Council’s RFI Response Report

DA No : DA2023/0987

35-43 Belgrave Street
Manly NSW 2095

Issued
05 December 2023

Amended proposal

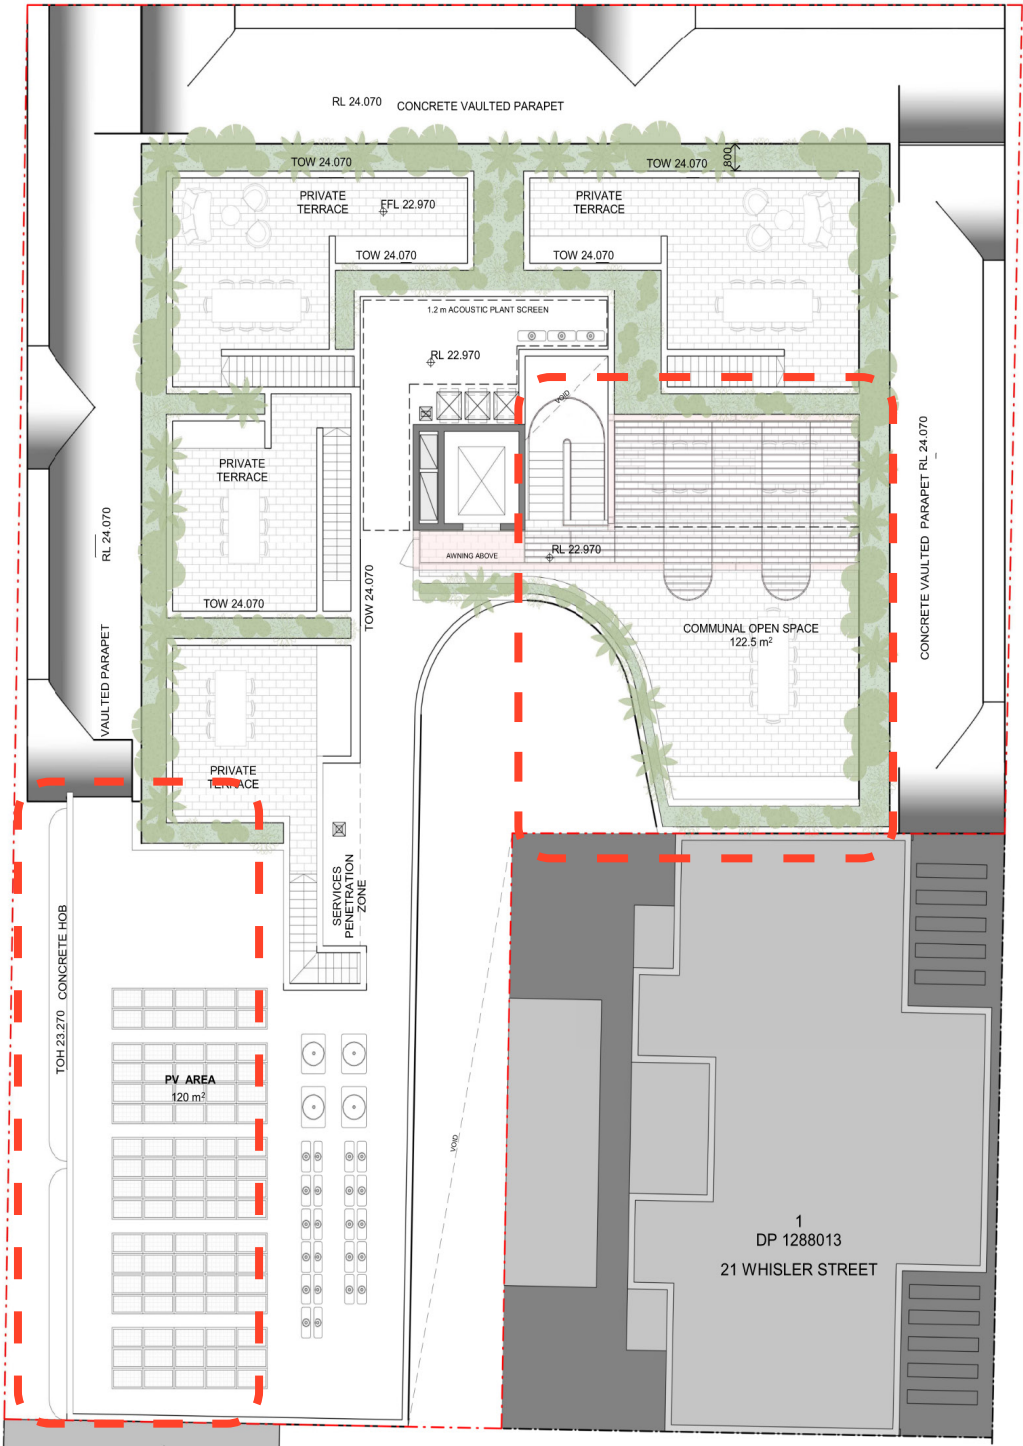
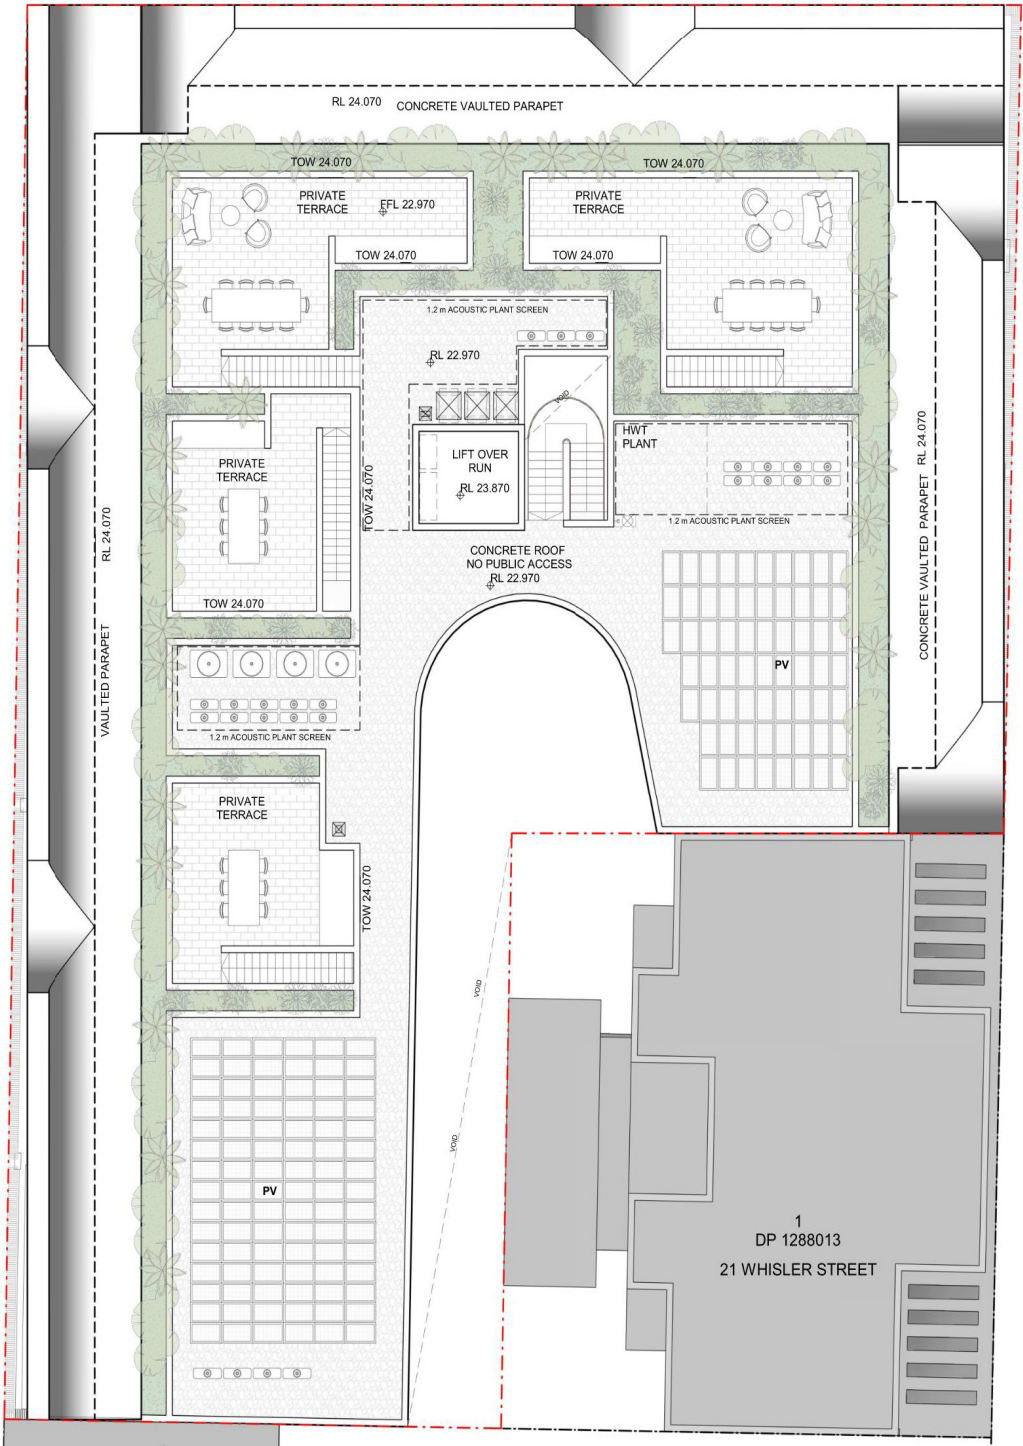
The proposed variations to the building height plane are not supported. The vaulted surroundings are above the height plane and add unnecessary building bulk and overbearing impact on the streetscape. The site comprises a number of lot and is only becomes a corner site by consolidation. The curved edge and arched vaulted elements must be lower to the 4th level. Deliberately accentuating the height plane breach is not consistent with the Manly Townscape and design excellence principles. The vaulted 5th level creates unnecessary solar and overshadowing impacts on adjacent properties as well as the streetscape including impacts on the outlook and view amenity from adjacent apartments views toward Ivanhoe Park and Manly Oval. The use of the top floor for private terraces denies the chance to include meaningful communal open space at this level and minimise the height breach. The clause 4.6 provided is not well founded and the environmental planning grounds to justify the excessive height plane breach are not evident or caused by any site constraints. The proposal is not supported pursuant to clauses 3.1.3 Townscape of the Manly Development Control Plan (MDCP), clause 4.2.2 Height of buildings (consideration of exceptions) and clause 4.6 Exceptions to development standards of the Manly Local Environmental Plan (MLEP) 2013. The top floor private terraces must be deleted with the edge setback in favour of single smaller communal open space. The vaulted and curved parapet around the building edge is to be deleted. It is considered that floor space will influence the volume of the overall building and therefore contributes to the height variation across the whole or significant elements of the building.

Corner site

The main portion of the site is a corner block with three street frontages. The portion of the site that fronts Belgrave Street and aligns with 21 Whisler Street has been amended in response to streetscape bulk commentary whilst maintaining the playful roof form to the corner portion to the north.

The roof plan has also been modified to accommodate communal rooftop access by extending the lift core and consolidating PVs and rooftop services to create a semi-sheltered roof top terrace.

Ground Floor Plan showing the hydrant booster located on Belgrave Street and extended retail frontage on corner

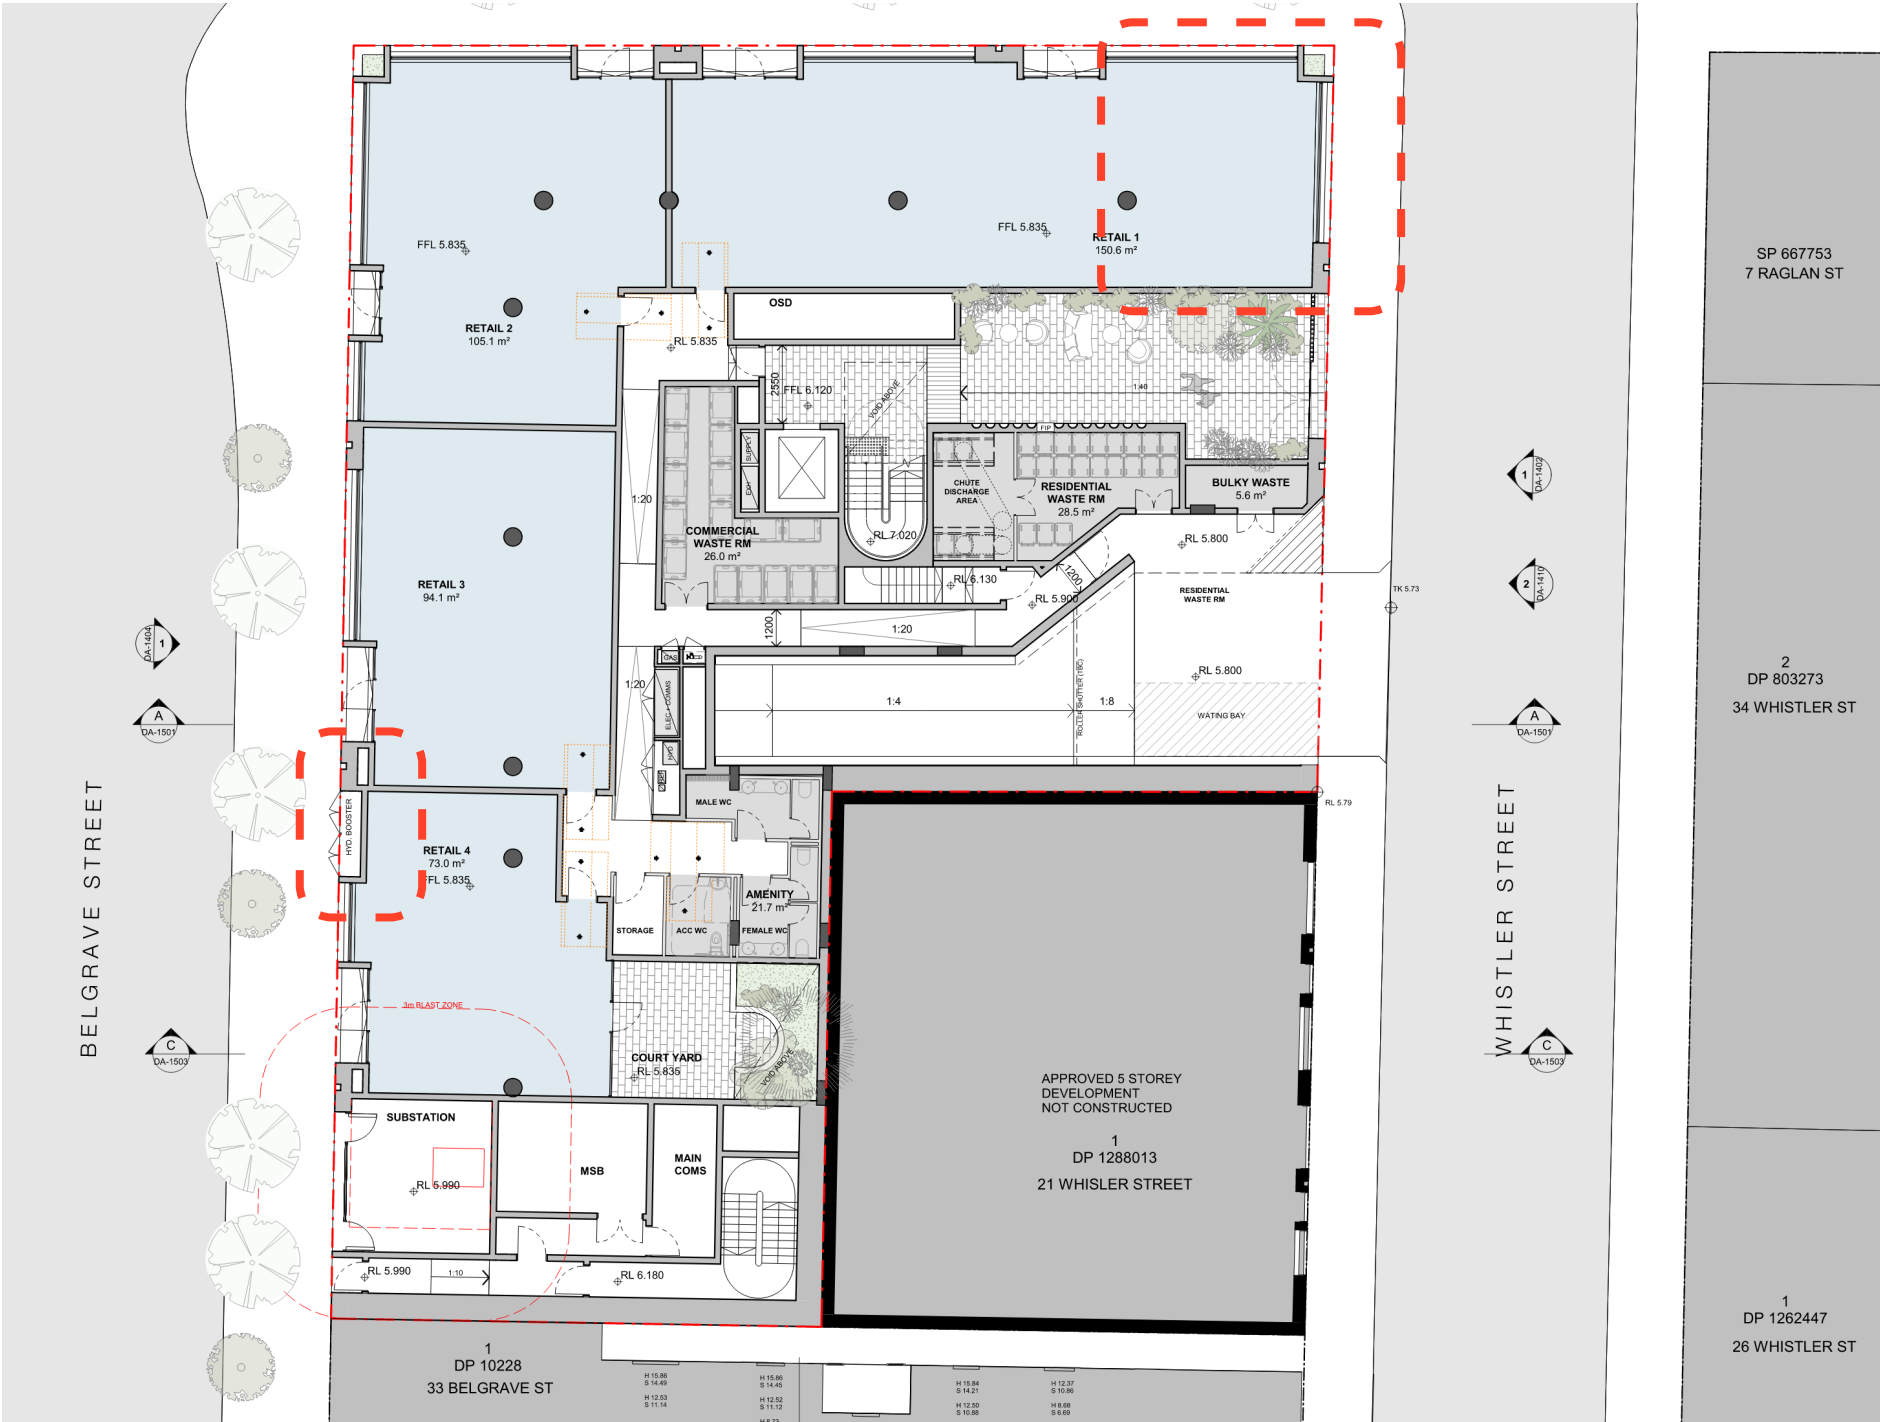
The proposal has limited street activation for retail frontage along Whistler Street due to the potential hydrant booster. It should be confirmed if the booster can be in the alcove on the northern side wall of the driveway entry point. DSAP also provided advice to investigate the booster location on Belgrave Street as the preferred alternative.

- The Hydrant Booster is located on Belgrave Street, giving an extended retail frontage on the corner of Whistler and Raglan Street.

Ground Floor Plan showing amended residential bin rooms in comparison with lodged DA plan

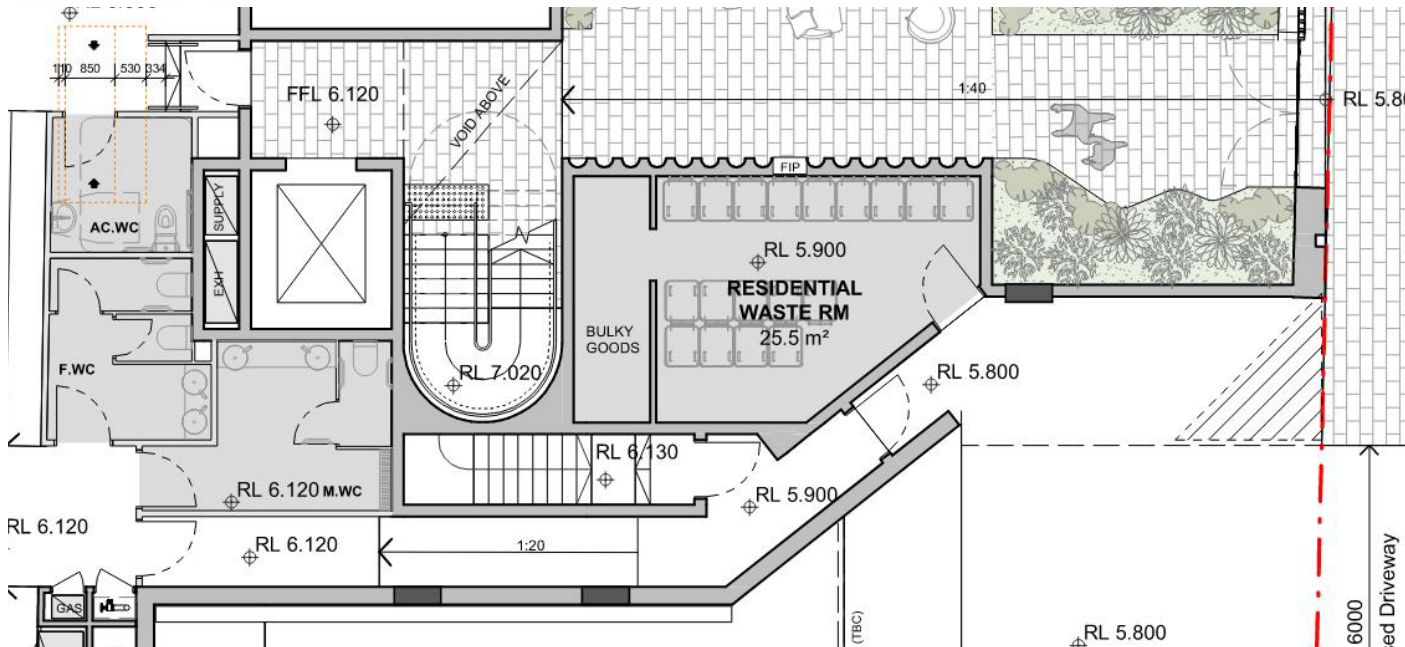
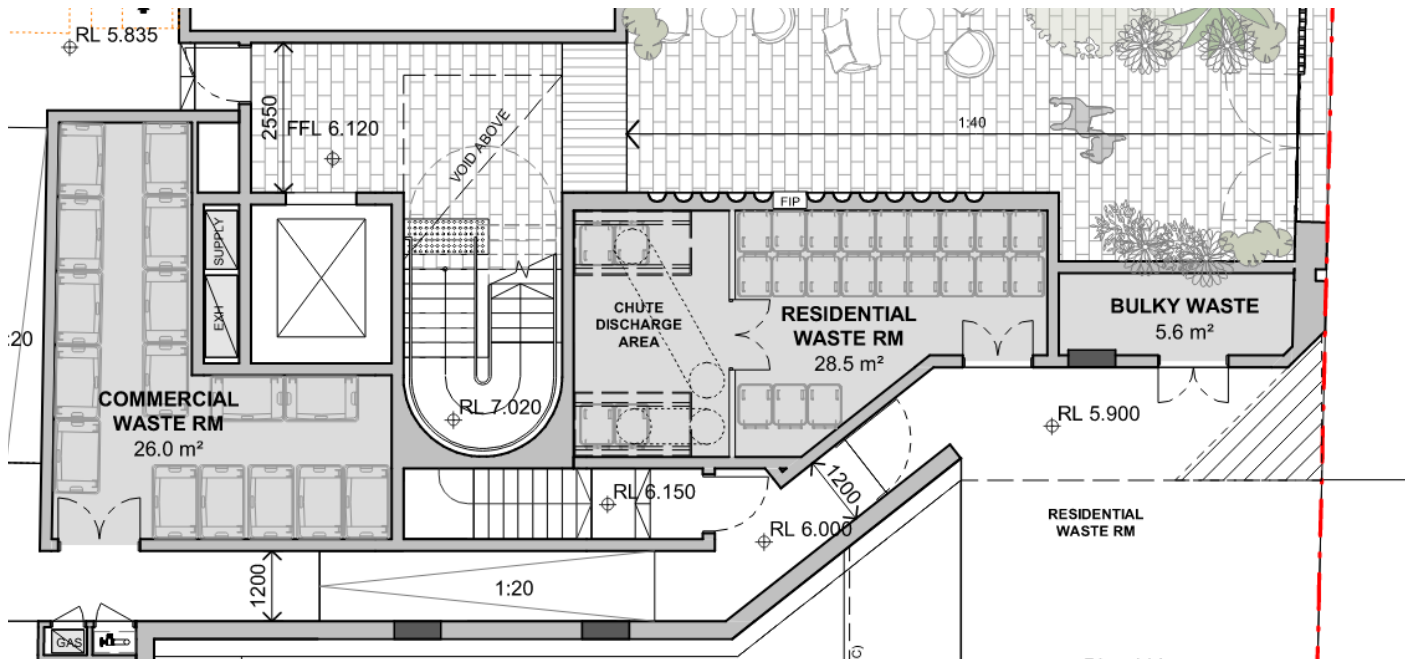
The residential bin room will need to be sized appropriately to store 25 x 240 litre bins. Additionally, the use of residential waste bin chutes and carousels is discouraged due to potential fouling, spillage and high maintenance required for daily management. The plan of management has no details of how such roles and responsibilities will be reliably implemented. If a carousel system is used a separate bin room will be required to ensure spilled materials do not create OHS slip/trip hazards for collection staff within the bin room. The residential recycling bin cupboards on each level show only one bin space, which is insufficient capacity for 7 days. Operationally, full-for-empty bins would need to be rotated mid-week and the proposal does not address this in the plan of management. Access to the bulky goods room is through the residential bin room. This is unacceptable. A separate door will be required to access the bulky goods room. The door must be 1.2m wide and open toward an outward direction to be latched open. For the proposed 25 residential units a bulky goods room of 10 cubic metres is required and will need a floor area of 5sqm. The proposal is not supported pursuant to Clause 3.8 Waste Management of the MDCP

- The amended proposal allows a larger residential bin room to accommodate 25 x 240 litre bins and handling space.
- A separate chute discharge area has been incorporated as recommended by the Council's waste referral.
- The bulky waste room is separated from the bin room and has dedicated access from the open area.
- An updated Waste Management Plan has been included in this submission. The revised plan clarifies and supports the use of garbage chutes and recycling bins on each floor. The plan specifies the regular bin-changing requirements for the building manager.

Building Section through amended roof parapet showing building height in relation to outlook and view amenity from adjacent buildings.

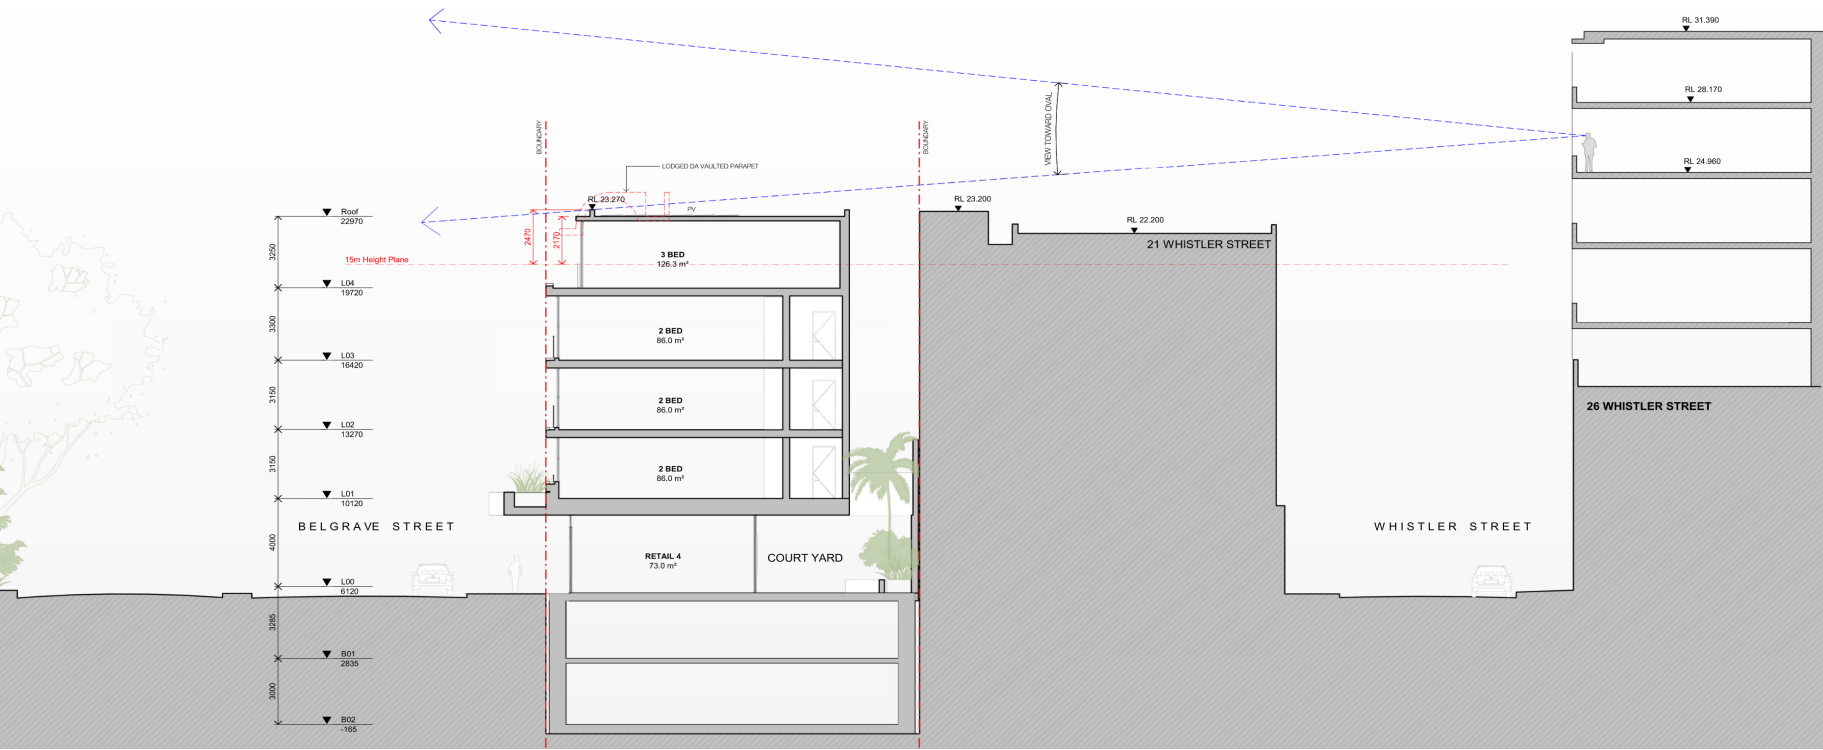
View and amenity impact concerns have been raised by No.26 Whistler Street, in particular Units 601 and 701. Whilst the MDCP considers some additional height for corner sites in the CBD may be appropriate (as per Clause 4.2.2) this should not be interpreted as being acceptable where any height non-compliance impacts views and amenity of surrounding residential land. View and amenity concerns, created by non-compliant building height will be given considerable weight. Therefore, it is requested that photomontages are provided demonstrating a comparison with a fully compliant scheme, and scheme incorporating the changes outlined above regarding (Building height, Streetscape and Bulk) as well as the existing scheme lodged. It is noted that an analysis should account for DA2018/1669. However, the proposal is currently not supported pursuant to Clauses 4.2.5.2 Height of Buildings and 3.4 Amenity of the MDCP.

The southern portion of the site which aligns with 26 Whistler Street has been amended as detailed in the previous pages. The vault has been replaced with a 300mm concrete hob to mitigate the concerns of view loss from Units 601 and 701 at 26 Whistler Street.

A separate view analysis has been conducted and included with this submission to provide a thorough understanding of the impact of the proposed development on 26 Whistler Street.
